**OGMCOAL - 1st Qtr 2010 Water Quality Memos**

# WATER QUALITY MEMORANDUM

RE: 2010 1st Quarter Water Monitoring, Sunnyside Cogeneration Association, Sunnyside Refuse/Slurry, C0070035, WQ010-1, Task 3487

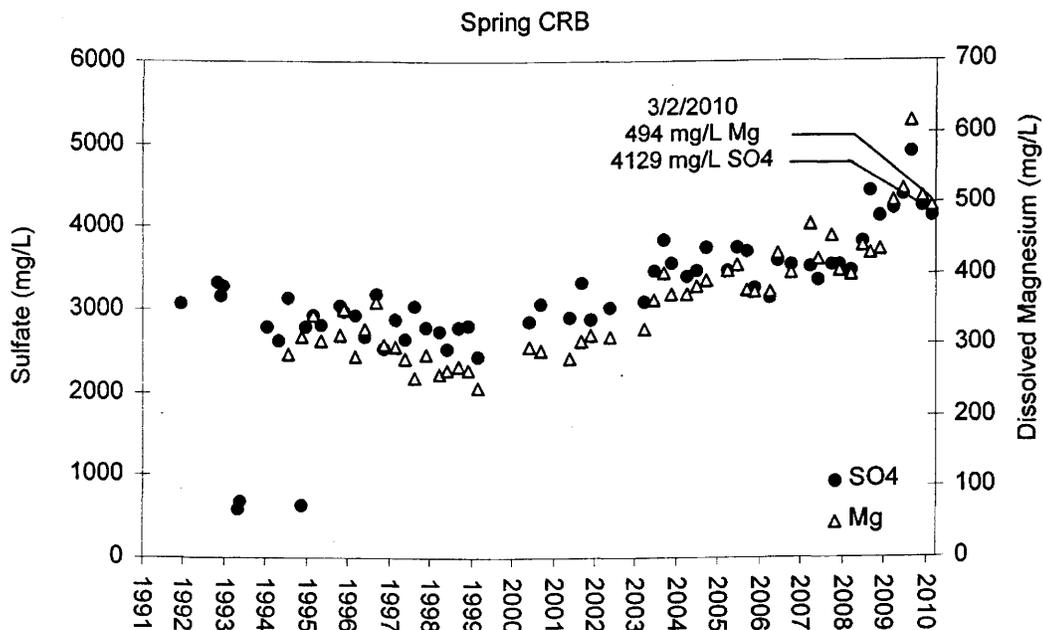
Dissolved magnesium and sulfate concentrations appear to be increasing at spring monitoring location CRB (see plot on following page). The concentrations reported for first quarter 2010 are consistent with recent data, as shown in the plot.
